5.2 NO. 188 (LOT: 1; D/P: 33790) VINCENT STREET, NORTH PERTH - PROPOSED ALTERATIONS AND ADDITIONS TO PLACE OF WORSHIP

PURPOSE OF REPORT:

To consider an application for development approval for alterations and additions to the Redemptorist Monastery and Church at No. 188 Vincent Street, North Perth (the subject site).

PROPOSED NEW SACRISTY ROOF PLAN
SCALE 1:50

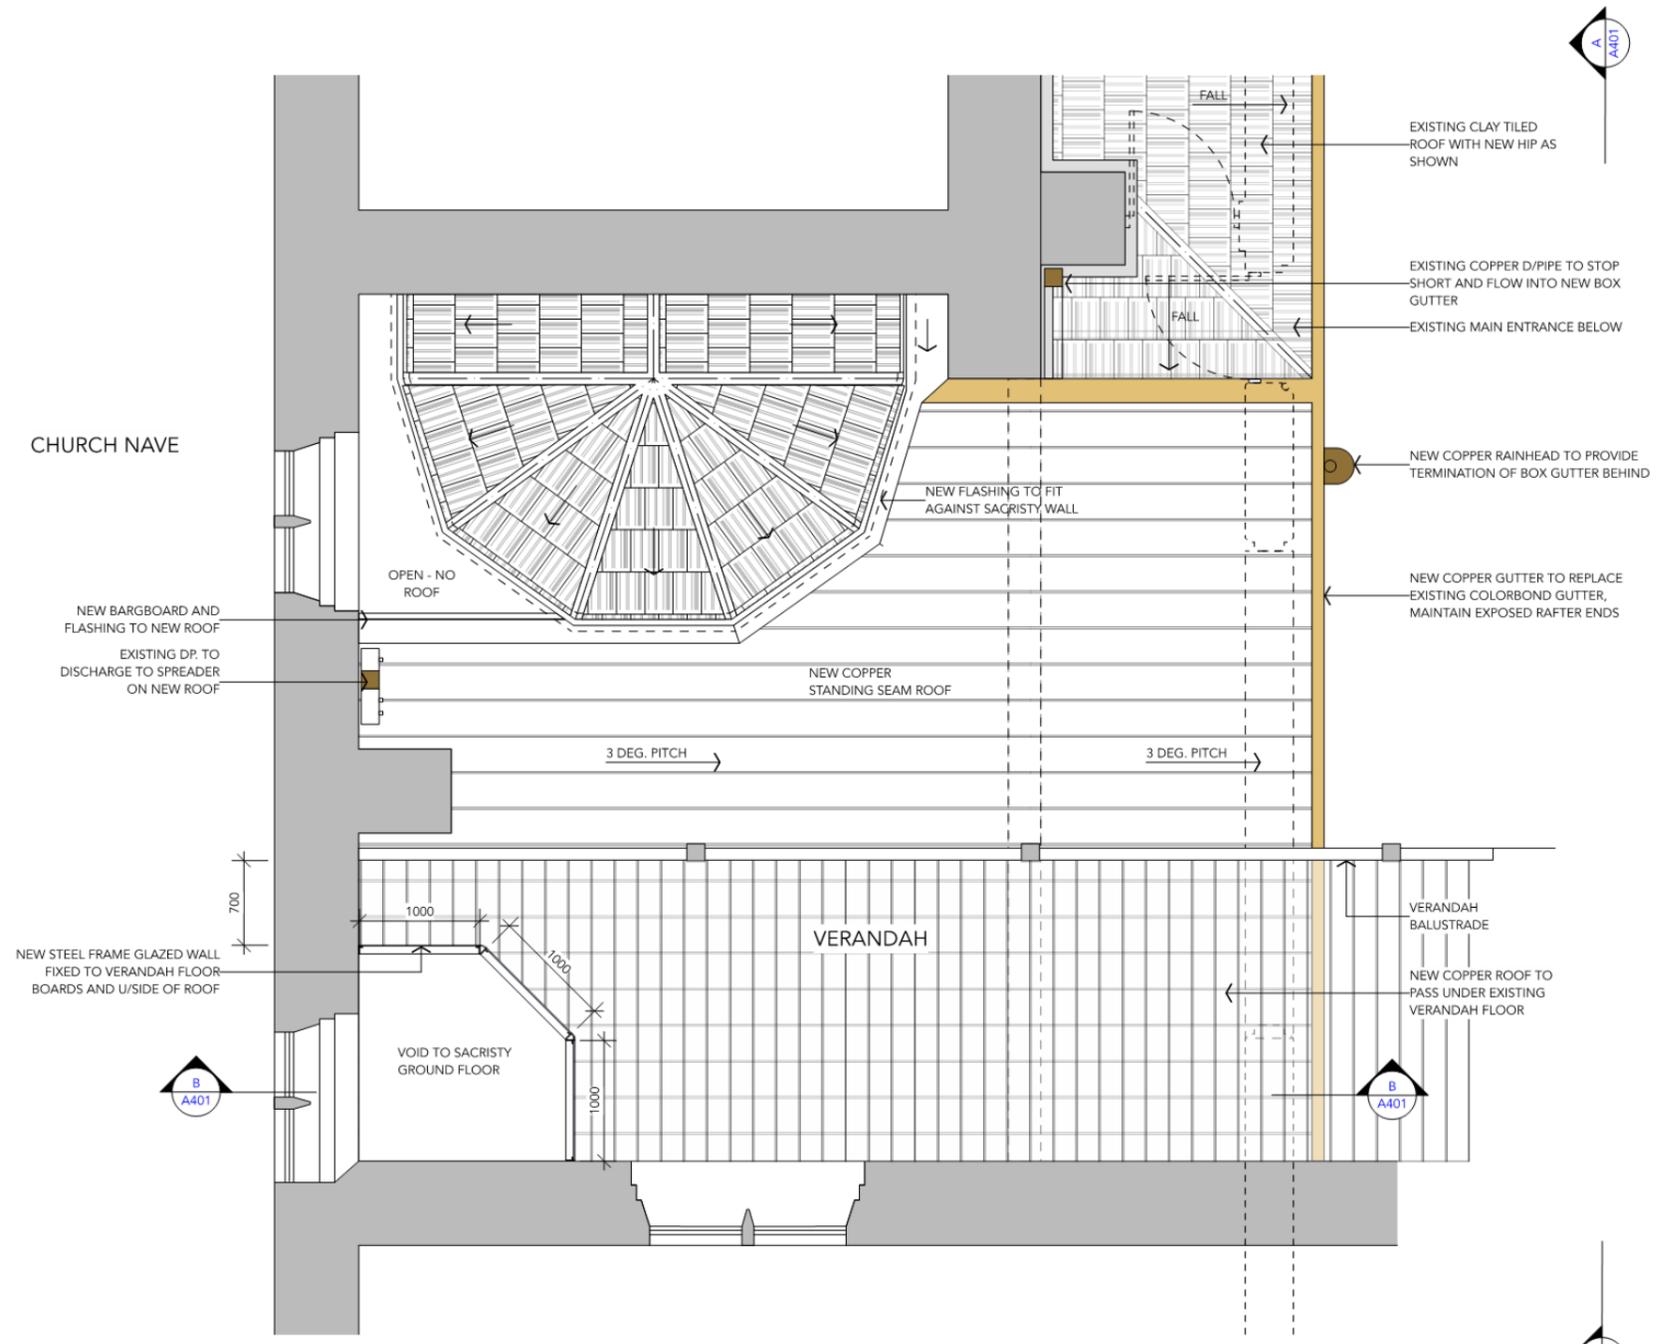
The proposed development complies with all of the acceptable development standards of the Heritage Management Policy, with the exception of the angle of the proposed roof of the Working Sacristy and adjacent corridor.

- Roof: The replacement of the working sacristy and corridor roof would be acceptable for the following reasons:
 - The replacement of the existing roofs with a skillion roof form would resolve the existing roof drainage issues and enable better management of stormwater on site. The working sacristy was originally an open courtyard. Over time roofing has been added to enclose the space. The working sacristy roof drains to a number of valley gutters and shows evidence of water damage from roof leaks. The simplified roof form would support easier ongoing maintenance conservation of the heritage place;

- Seamed copper is already used on the building, specifically the sacristy. The use of an existing material assists with integrating the roof and the existing building and is sympathetic to the heritage place. The use of copper material is also supported by the DRP member;

- The use of a light colour (<0.4 solar absorptance) material would not be supported in this situation. This is because the colour would not be in keeping with the character of the heritage place and would not assist in integrating the works with the existing building design; and

- The working sacristy is bounded by the church to the west, east transept to the north and the monastery to the south. It cannot be seen from Camelia Street to the east due to the Retreat House and additions to the eastern wing of the monastery in 1912. The modification of the roof form would not affect the existing vistas from adjacent streets and would not affect the aesthetic values of the heritage place; and
